SERVICE BULLETIN

B-064 Safety Recall Code 0831

P&A Accessory Tall Windscreen Part Nos. 58214-06Y and 58214-06YA

Figure 2. Mounting Hardware for Tall Windscreen

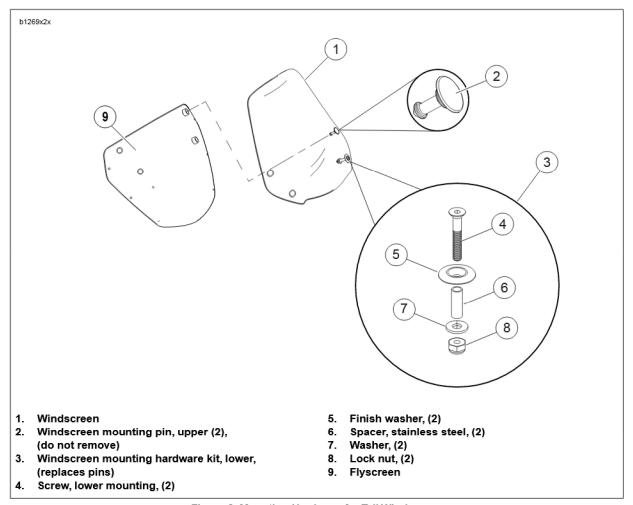
See Figure 2. The windscreen (1) upper mounting locations use mounting pins (2) (Factory installed in windscreen) and the lower two mounting locations use fasteners (3) supplied in the 94485Y recall kit. It will be necessary to remove the flyscreen in order to properly install the new windscreen lower fasteners.

The windscreen **MUST** be installed to the flyscreen while both components are off the motorcycle. The lower fasteners can not be installed if the flyscreen is left installed on the motorcycle.

- See Figure 2. Install the windscreen (1) by pushing the upper mounting pins (2) into place. Ensure upper mounting pins on windscreen locate properly into upper mounting grommets of the flyscreen.
- 4. Align the lower flyscreen and windscreen mounting holes. For the left and right side lower mounting holes, insert finish washer (5) and spacer (6) onto the screw (4) and place through the windscreen holes and flyscreen grommets.

- 5. From the inside of the flyscreen place washer (7) onto the screw (4) and thread lock nut (8) onto screw. Tighten screw to 50-60 **in-lbs** (5.6-6.8 Nm).
- Install flyscreen (with windscreen attached) using 6 screws removed earlier. Tighten screws to 10-12 in-lbs (1.1-1.4 Nm).
